Access Compliance Report

Public Rights-of-Way

(Curb Ramps)

Intersection ID: 44109	Main Street: TRAHERNE_CT	Cross Street: STAFFORDSHIRE_LN	Location: NE
ADA ID: B3F0D98928A4	Ramp Type: Perp	Initial Pass/Fail: Fail	Overall Compliance: No
Severity Score: 13.75			
Codes/Mitigation Info/Possible Solution		Field Measurements/Component Compliance

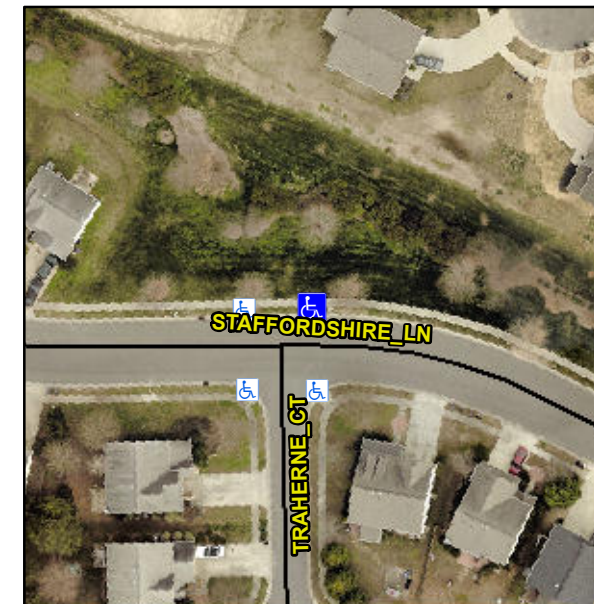
Not Found, R304.2.2

Compliance	Description	Data	Compliance	Description	Data
N/A	Ramp Length (in)	48.0	No	Ramp Slope (%)	11.8
Yes	Ramp Width (in)	48.0	Yes	Ramp XSlope (%)	3.7
N/A	Flare Type LT	N/A	N/A	Flare Type RT	N/A
N/A	Flare Slope LT (%)	N/A	N/A	Flare Slope RT (%)	N/A
N/A	Flare Traversable LT?	N/A	N/A	Flare Traversable RT?	N/A
N/A	Landing Length (in)	N/A	N/A	DWS Provided?	N/A
N/A	Landing Width (in)	N/A	N/A	DWS Contrast?	N/A
N/A	Landing Slope (%)	N/A	N/A	DWS Length (in)	N/A
N/A	Landing X Slope (%)	N/A	N/A	DWS Full Width?	N/A
N/A	Landing Curb? (Y/N)	N/A	N/A	DWS Offset (in)	N/A
N/A	Shared Landing?	N/A			
N/A	Gutter Ponding?	N/A	N/A	Gutter Slope (%)	N/A
N/A	Gutter Lip Ht (in)	N/A	N/A	Gutter X Slope (%)	N/A
N/A	Painted X Walk1?	No	N/A	Painted X Walk2?	N/A
	X Walk 1 Direction	To S		X Walk 2 Direction	N/A
N/A	X Walk 1 Width (in)	N/A	N/A	X Walk 2 Width (in)	N/A
	X Walk 1 Slope (%)	3.2		X Walk 2 Slope (%)	N/A
	X Walk 1 X Slope (%)	3.8		X Walk 2 X Slope (%)	N/A

Remove & Replace Entire Ramp.
